Our ref: 70014753-003

Subject: 55 Fitzroy Park PA 2018/3672/P - Construction Management Plan Technical Review

WSP has been appointed by The Fitzroy Park Residents Association (FPRA) to review and advise them on the suitability and acceptability of the Construction Management Plan, prepared by Montway Ltd and submitted as part of planning application 2018/3672/P, for a new residential development at 55 Fitzroy Park, Highgate.

DRAWING NO: 7453-003-ATR-001

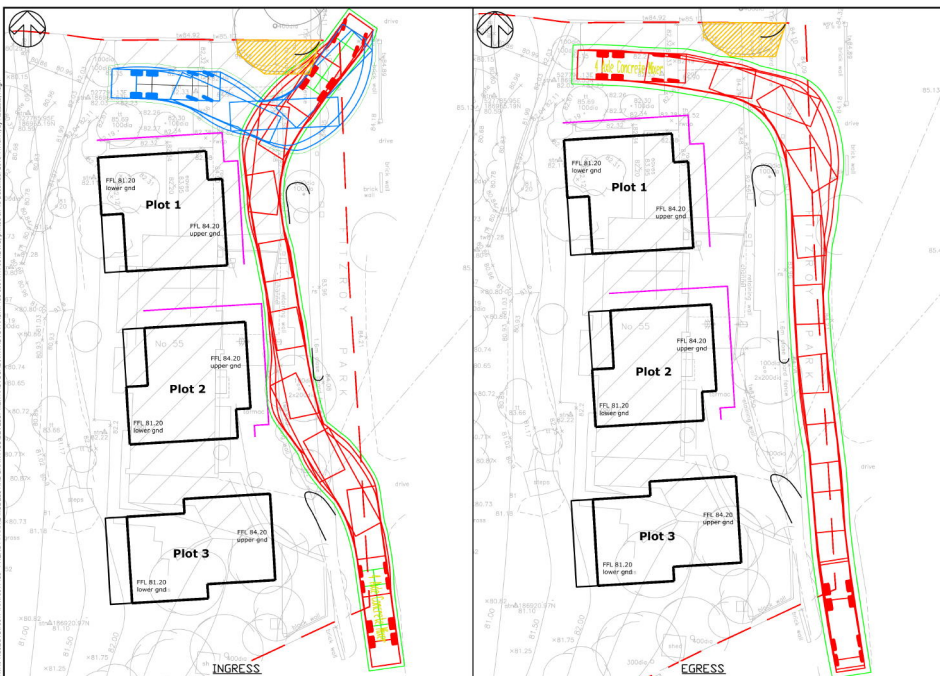
For the purposes of the CMP review, WSP has undertaken an independent swept path analysis of a 4-axle, 8m³ concrete mixer, entering and exiting the site, based on the constraints and site arrangement for Phase 2. The WSP swept path analysis includes a clear buffer of 0.5 metres to allow for such things as vehicle wing mirrors which extend outside the vehicle profile and provide a suitable margin for error or data inaccuracy from any physical constraints. The analysis was completed with no use of 'turning on the spot' and used a driving speed of 1 km/hr in both directions. For our review we have shown the tree protection fencing zone as per BoskyTrees plan 'TPP-1'.

The swept path analysis (refer to enclosed 7453-003-ATR-001) confirmed that the ingress movement would overrun the root protection zone of tree T570 located within the neighbouring 53 Fitzroy Park.

The combination of a larger vehicle and avoidance of the tree protection fencing / zone lead us to the fair and reasonable predication a greater number of movements than shown within the existing CMP will need to be undertaken for the concrete mixer to unload, turn around and depart from site.

SCALE @:	1:250	CHECKED:	MS	APPROVED:	JOC
PROJECT NO:	70017453	DESIGNED:	MS	DRAWN:	MR
				DRAWING NO:	7453-003-ATR-003
				DATE:	November 18
				REV:	A

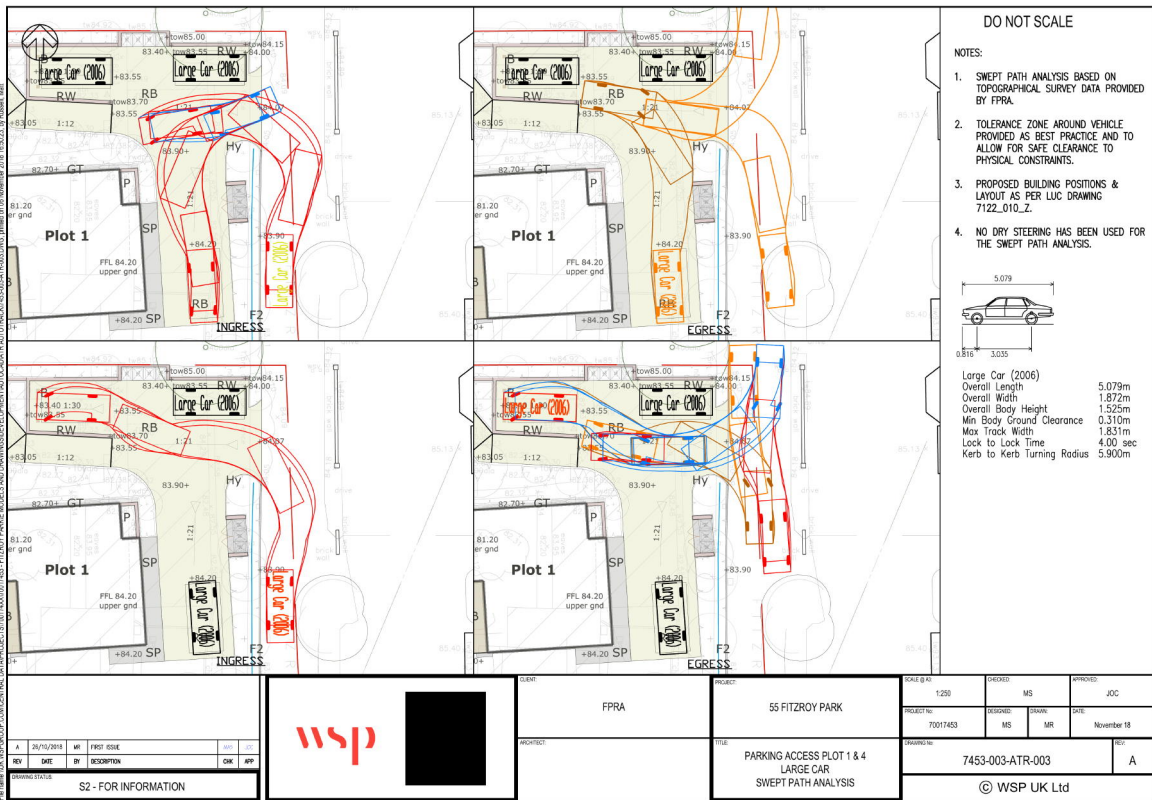
The swept path analysis (refer to enclosed drawings 7453-003-ATR-002 to 004) confirmed the following:

- The analysis shows without the use of dry steering vehicles will require multiple movements to position a large car into each parking space and to exit onto Fitzroy Park.
- This is particularly emphasised for Plots 2 and 3, where for Plot 3 the analysis shows that up to 12 movements would be required for a large car to exit onto Fitzroy Park;
- Plots 4 and 5 are not able to turn around within the site and would exit via reversing onto Fitzroy Park. This was also reflected on Royal HaskoningDHV drawings TR25 and TR27. Under the Highway Code reversing in and driving out of a driveway is recommended and where possible it should be designed out.

Based on the swept path analysis undertaken by WSP we suggest that the analysis presented by the applicant may not be reflective of the actual usage of the spaces and may need to be revisited.
